RE: Permit No. 522.

INSPECTION REPORT

TO FILE: Teton Exploration Drilling, Inc., Permit Number 522
FROM: Cathleen McCarty, ^{64m}District I Environmental Specialist
DATE: October 10, 1985
SUBJECT: NRC/DEQ Inspection Conducted on September 23 and 24, 1985.
PARTICIPANTS: Dick Appel, Teton
Roger Garling, Teton
George Pangburn, NRC
Randy Brich, NRC
Lisa Geesey, LQD District I
Cathy McCarty, LQD District I

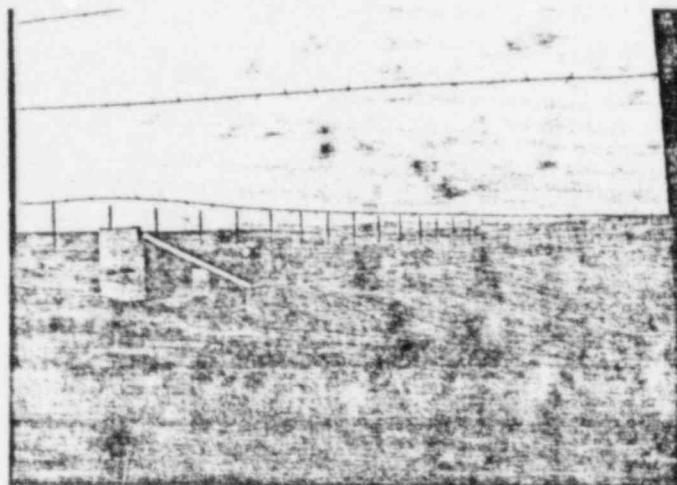
When a hole is dug to cut off the casing the topsoil is segregated from the overburden. The topsoil is marked with a yellow flag. While digging the pits to cut off the casings some past drilling mud pits that register on the scintillometer were uncovered. Mr. Appel stated that the muck from these pits would be removed to a licensed disposal facility and the area re-surveyed. Photograph number 4 is looking across the "N" zone wellfield. Well casing pits and the water retention pit used while pumping Well MR-1 can be seen in this photograph.

Photograph number 2 is looking west at the barium chloride tank used to treat the south pond's water as it was discharged.

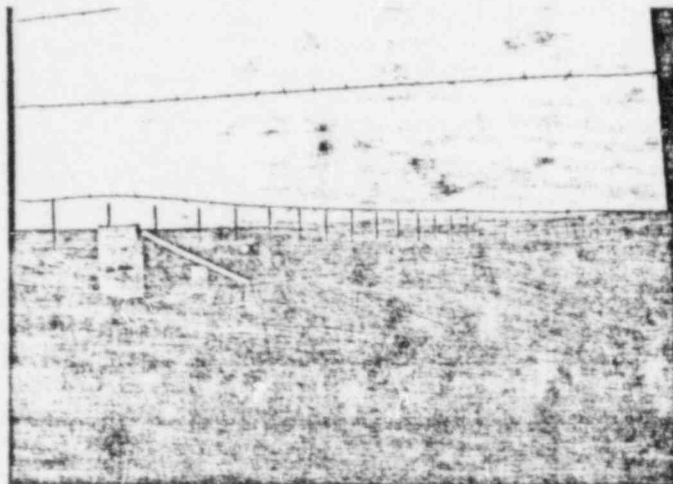
Before well MR-1 was pumped into the south evaporation pond, the water from the pond had been discharged twice under a one time NPDES discharge permit. As can be seen in photograph number 2 the water being discharged was treated in a barium chloride and then run through a settling tank. The settling tank is located below the ponds on the west side. After the water went

through the settling tank it was discharged onto wooden skids. The skids were to dissipate the water's energy and prevent erosion. No erosion was occurring from the discharge. Radiological readings at contact with the ground immediately adjacent to the discharge was 150 micro R/hr.
